ANNEXATION REPORT & STAFF REPORT

Swan Ranch II Annexation **Summation**

CASE NUMBER: UDC-13-00071

PROJECT:	SWAN RANCH II
DRAWING TITLE:	ANNEXATION MAP

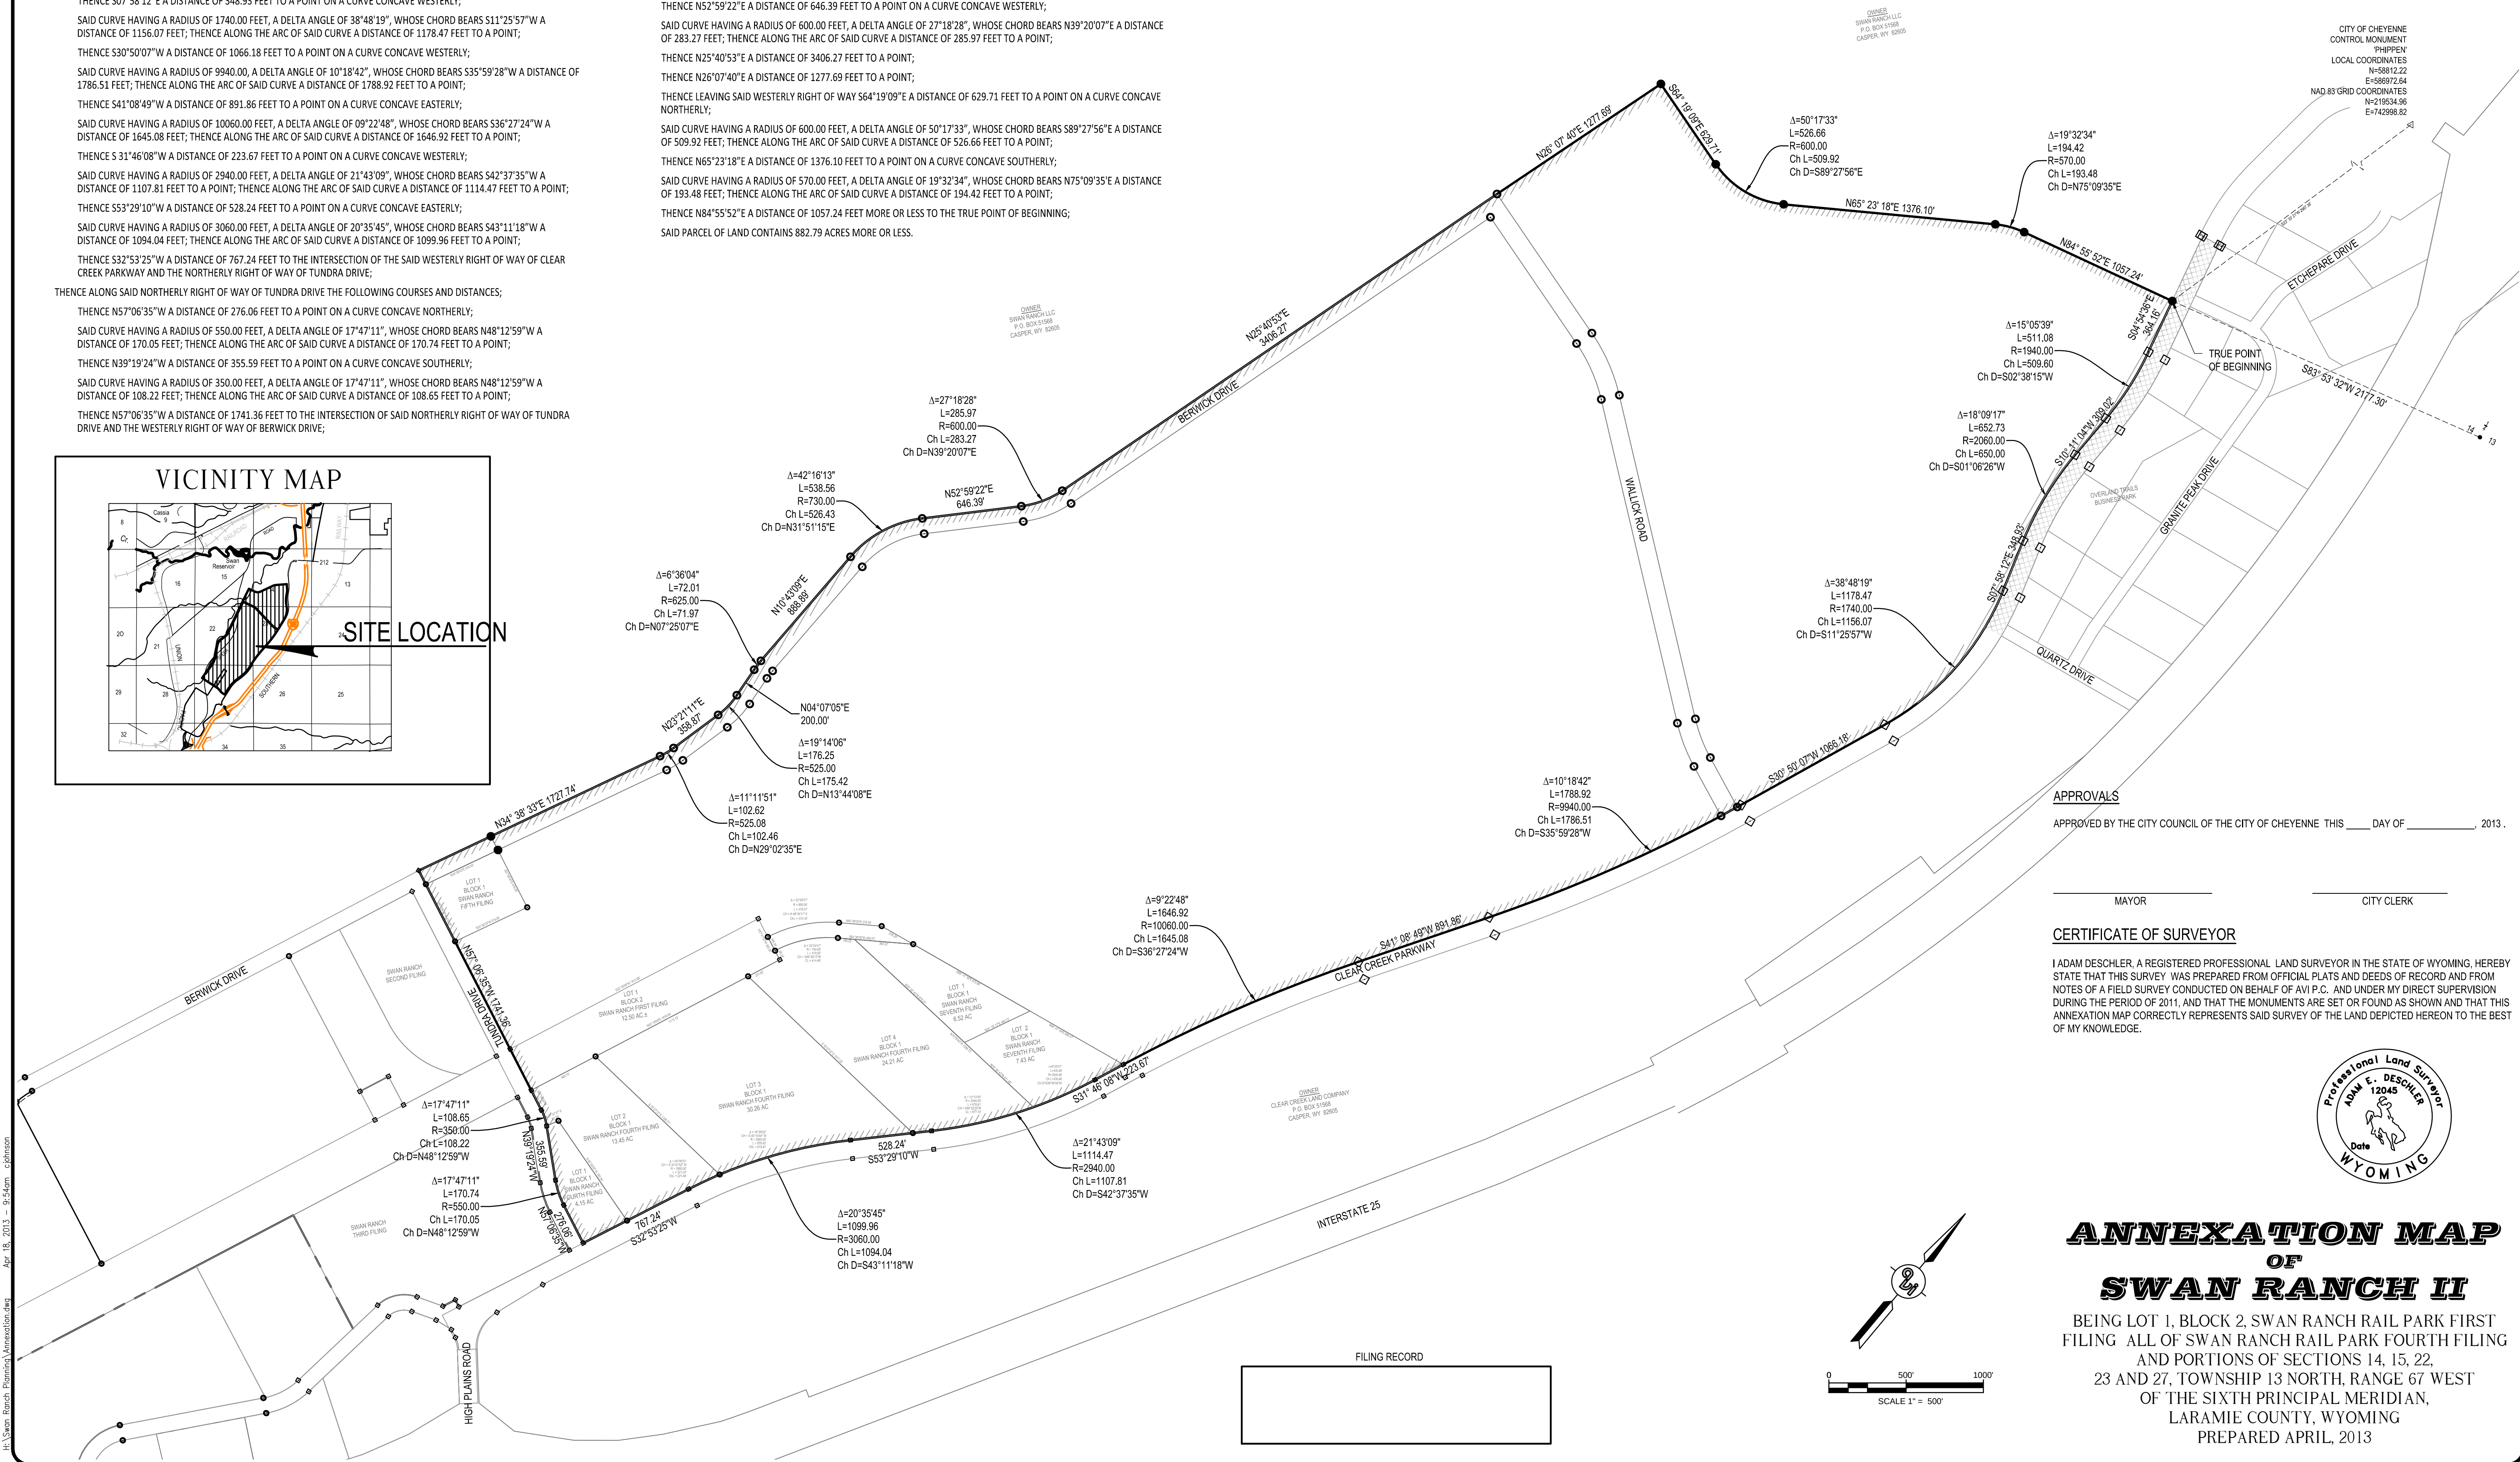
My only concern with the annexation map and legal description involves the absence of any mention of the plats lying within the annexation boundary. This has already been discussed with Planning. I otherwise have no comments.

Should the Rights-Of-Way of Tundra Drive and Clear Creek Parkway be included in this annexation? Berwick Drive is included. (Note: Please see report for explanation.)

1. Change name (Swan Ranch II Annexation)
2. Replace shaded line for existing City limits with different hatch markings.

2. The one minor discrepancy found between the boundary and LEGAL DESCRIPTION involves the tenth course in the LEGAL DESCRIPTION. In the legal, the radius of the curve recites 10060.02', but in the curve data on the map it recites 10060.00'. This 0.02' discrepancy needs to be corrected in one location or the other.

3. In the CERTIFICATE OF SURVEYOR it recites "...and that the monuments are set or found as shown...". However, the survey corners are not shown, and are required to be shown. These should also be described in the LEGEND.

4. The VICINITY MAP does not clearly show the area to be annexed. A crosshatched or shaded area needs to be provided and properly labeled. Is the VICINITY MAP to scale?

5. The TITLE BLOCK is incomplete, and should read as follows: ANNEXATION MAP OF SWAN RANCH BEING LOT 1, BLOCK 2, SWAN RANCH RAIL PARK FIRST FILING; ALL OF SWAN RANCH RAIL PARK FOURTH FILING; AND PORTIONS OF SECTIONS 14, 15, 22, 23, AND 27, TOWNSHIP 13 NORTH, RANGE 67 WEST OF THE SIXTH PRINCIPAL MERIDIAN, LARAMIE COUNTY, WYOMING.

6. "Dimensional information from the recorded plat(s) of the parcels being annexed must be shown." Therefore, Lot 1, Block 2, Swan Ranch Rail Park First Filing; and all of the lots within Swan Ranch Rail Park Fourth Filing must be properly shown, labeled and dimensional information provided.

7. "The names of the owners of abutting unplatted property and/or the names of adjacent subdivisions." This information must be provided.
8. Northeast of CONTROL MONUMENT "PHIPPEN" on the map is a set of what appear to be coordinates. I think they should be deleted?

9. There is no 1" x 4" FILING RECORD block provided for recording in the Laramie County Clerk's Office. This needs to be provided.

Urban Planning: (Note: These comments addressed by revised map.)

City Surveyor: (Note: These comments have been addressed with a revised map.)
